Product Update Memo

SENSORS AND CONTROLS PRODUCTS

Model 3540/41/43/45 Product Design Improvement

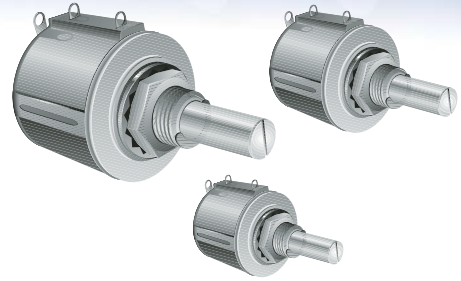
In line with our commitment to product excellence, Sensors & Controls Division is introducing a product design improvement to our popular [3540](#), [3541](#), [3543](#) and [3545](#) models. The design improvement entails a change to the cover/strap that is used to adhere the bushing to the housing. The cover serves a secondary purpose in keeping the bushing from rotating when the unit is installed on a panel. The design of the tab that locks the bushing in place has been improved to provide a more robust lock. The photos below show the change in design.

Old cover design

New cover design

Please note that this change does not affect form, fit or function of the product. Product will begin shipping with this improvement beginning with date code 0627X. There will be no changes to current prices, minimum order quantities or multiples for this improvement.
